2.1.3.3.3 Backfilled Erato Seepage

2.1.4 Project Water Balance

2.1.5 Mitigation Measures

Figure 2.1.2: Flow Chart - Water management during closure phase (Figure 6.10.3 of the ESIA)

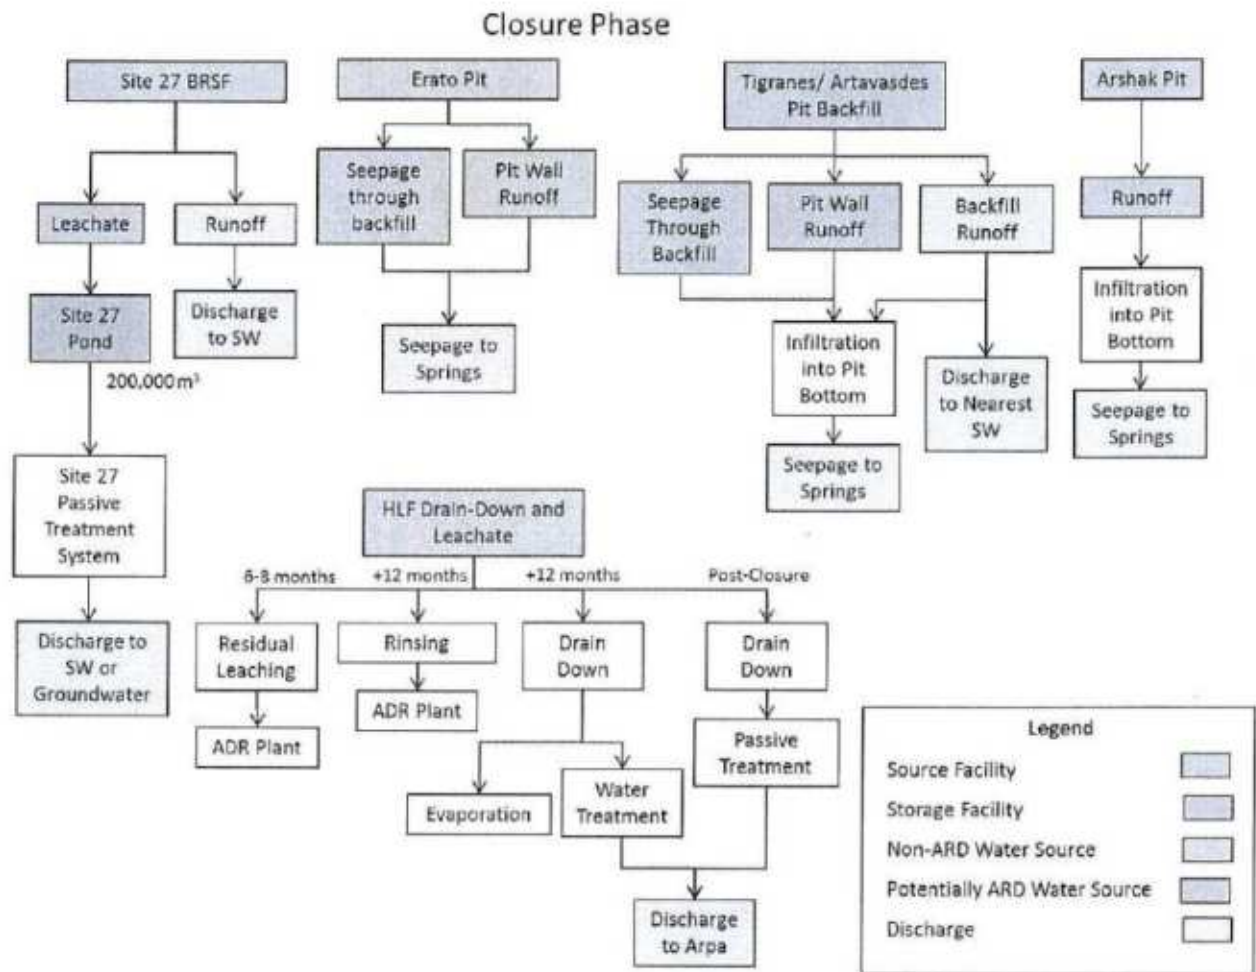
A flow chart of the water management during the closure phase presented as Figure 6.10.3 in Chapter 6.10 of the ESIA is shown below as Figure 2.1.2. The water from the residual leaching and rinsing are shown going to the ADR plant, and then inexplicably disappearing. GRE (2014d; page 71) gives an estimate of 2 million m³ of water in the HLF after rinsing. The water by this time has been in circulation for ten years and will have elevated levels of sodium, chloride, sulfate, nitrate and probably other ions as well. Assuming the volume of HL solution is in the same range as that remaining in the HLF after rinsing (*i.e.*, >1,000,000 m³), the management and disposition of such large volume of contaminated water should be addressed.
